Decommissioning Vermont Yankee January 26, 2011 Testimony

*Fairewinds Associates, Inc
Arnie Gundersen
Maggie Gundersen*

Decommissioning Vermont Yankee A Public Policy Discussion

2007 report is technically outdated

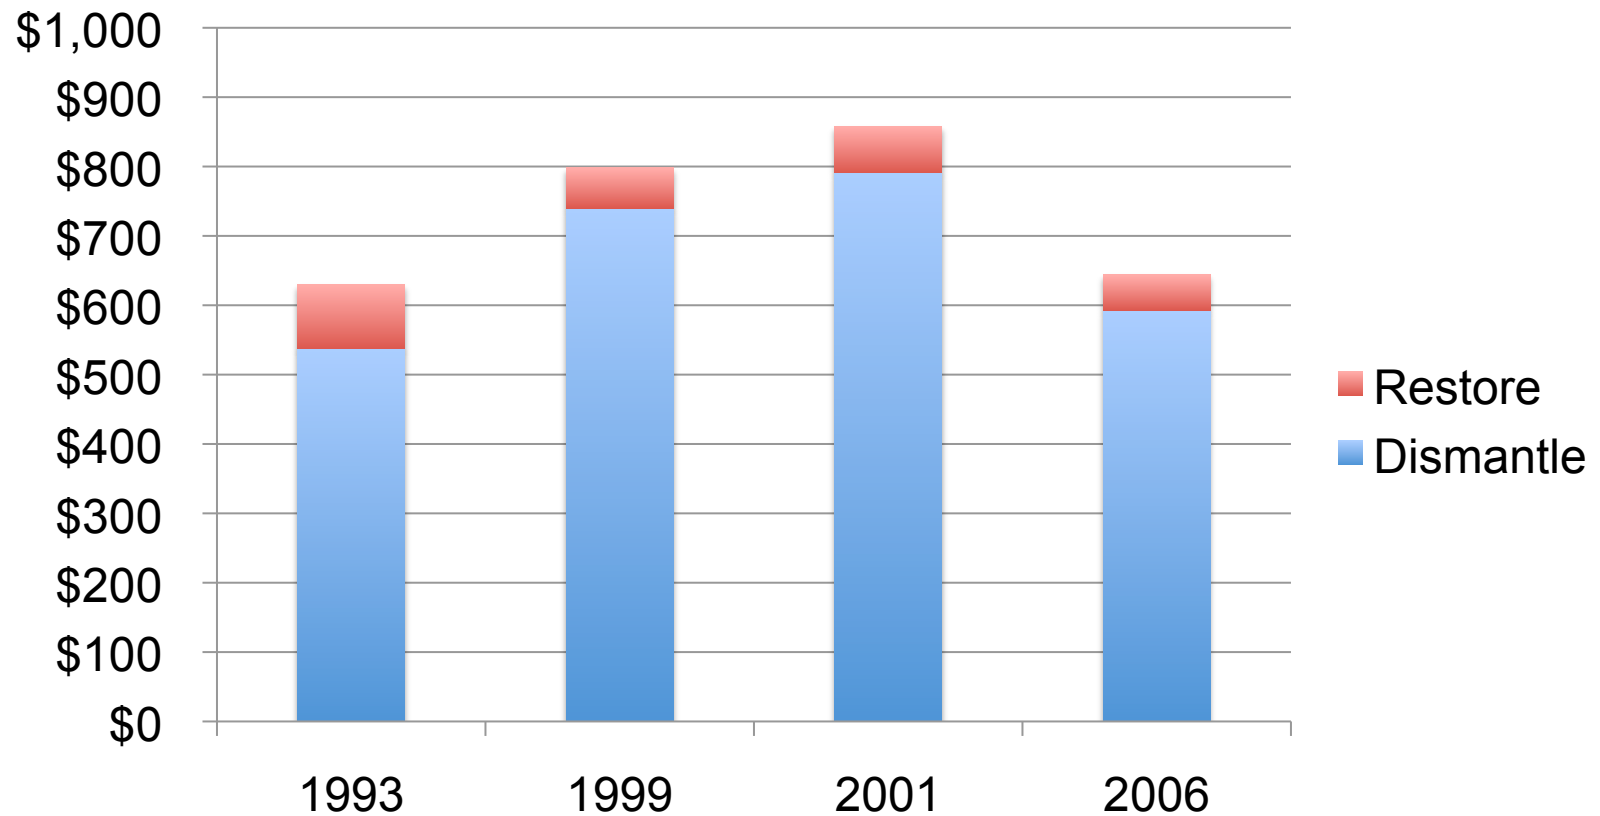
- Study of record written in 2006-cost escalation has changed
- New decommissioning approach lowers costs at Zion nuclear plant but generates more waste
- New computer technology optimizes waste shipments
- Site is significantly more contaminated than 2007 study assumes due to radioactive leaks
- Latest well (#24) was 2,500 pci/l in early December, 7,000 pci/l in late December and 9,200 pci/l in mid January 2011... disturbing trend
- 2007 study lacks clear cash flow for best case for VT
